Re: Florida Power & Light Company  
Proposed Turkey Point Units 6 and 7  
Docket Nos. 52-040 and 52-041  
Response to NRC Request for Additional Information Letter No. 082 (eRAI 7811)  
SRP Section 02.05.04 – Stability of Subsurface Materials and Foundations

**NRC RAI Letter No. PTN-RAI-LTR-082**

**NRC RAI Number: 02.05.04-29 (eRAI 7811)**

Figure 1 Median Stiffness for Lower Tamiami Stratum

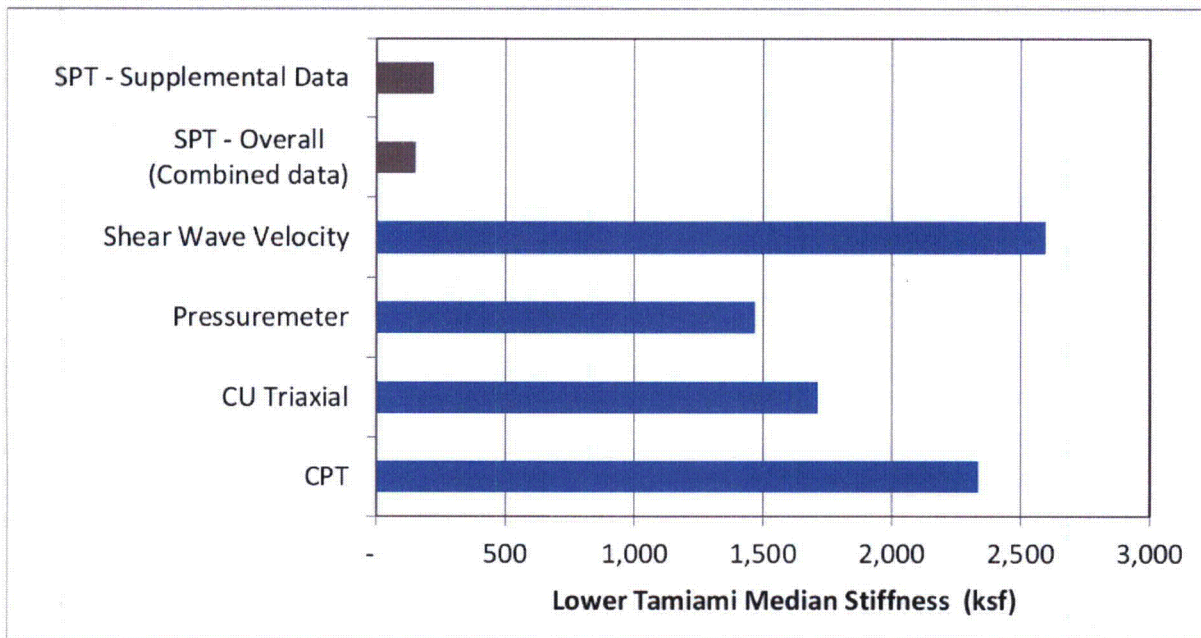
In response to RAI 02.05.04-5, the applicant stated in Note 1 of Table 3 that the SPT based stiffness for Lower Tamiami Formation is too low compared to values obtained from other methods, thus, it is disregarded in the overall average. However, the applicant also indicated in its response to RAI 02.05.04-2 and FSAR Subsection 2.5.4.2.1.3.2.1 that the overall pool of "SPT N" values from both the initial and supplemental investigations are used in development of engineering parameters or engineering analyses. In accordance with 10 CFR 100.23, please provide the following to assist NRC staff's further review in this area:

1. Calculations of the SPT based stiffness for Lower Tamiami Formation obtained from both the overall (combined) data pool and the supplemental test data.
2. Basis on why the SPT based stiffness for Lower Tamiami Formation can be selected to ignore, while the SPT based stiffness is used in the overall average for Upper Tamiami Formation and Peace River Formation, given the facts that the stiffness for Upper Tamiami Formation by STP method is reasonably agreed with the values by other methods and the stiffness for Peace River Formation by STP method is relatively higher than the values by other methods.
3. Clarification of engineering parameters or engineering analyses that are developed based on and/or not based on the overall pool of "SPT N" values.

1. SPT based stiffness for the lower Tamiami Formation (overall data pool and supplemental test data) is included in Table 1 and Figure 1, which also includes stiffness as obtained from other methodologies for comparison.

It is evident from Table 1 and Figure 1 that SPT based stiffness is approximately an order of magnitude less than the average stiffness obtained considering other methodologies.

SPT based stiffness for silty soils, i.e., the lower Tamiami Formation considering the overall data pool is only about 10% to 15% of the average obtained from other methodologies. All methodologies except SPT produce consistent results for the lower Tamiami Formation. Therefore, the recommended silty soil correlation presented in Reference 1 (Equation 2) is not considered applicable for the site specific conditions.

Figure 1 Bearing Pressure Distributions for Cases 1 through 4

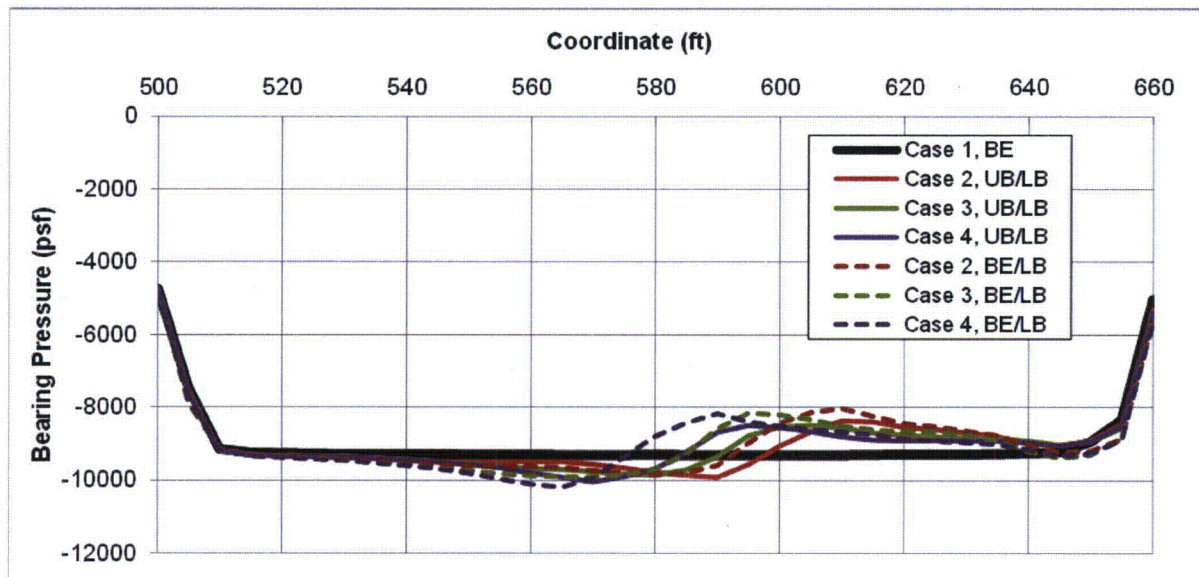
In response to RAI 02.05.04-9, the applicant conducted sensitivity study on bearing pressure uniformity. For the laterally variable case, the applicant assumed a scenario, in which, half of the foundation rests on the softer soil/rock column with lower bound (LB) parameters and half of the foundation rests on the stiffer soil/rock column with the best estimated (BE) parameters. In accordance with 10 CFR 100.23, please justify why upper bound (UB) parameters is not considered for the stiffer soil/rock column in the evaluation for the worst-case scenario.

The results of the UB/LB case are shown on Figures 1 and 2, where results from the BE/LB case (as presented in the Response to RAI 02.05.04-09) are also provided for reference. Figure 1 provides the bearing pressure distributions, while Figure 2 provides the percent bearing pressure difference with respect to the laterally uniform case. Case 1 represents the laterally uniform case, while Cases 2, 3, and 4 vary the width of the transition zone as one-third, one-fifth, and one-sixteenth of the foundation width, respectively. For both the UB/LB and BE/LB cases the maximum difference in bearing pressures is less than 20 percent, which meets the DCD criterion despite the extremely unlikely nature of the scenario and high level of conservatism involved in the analysis.
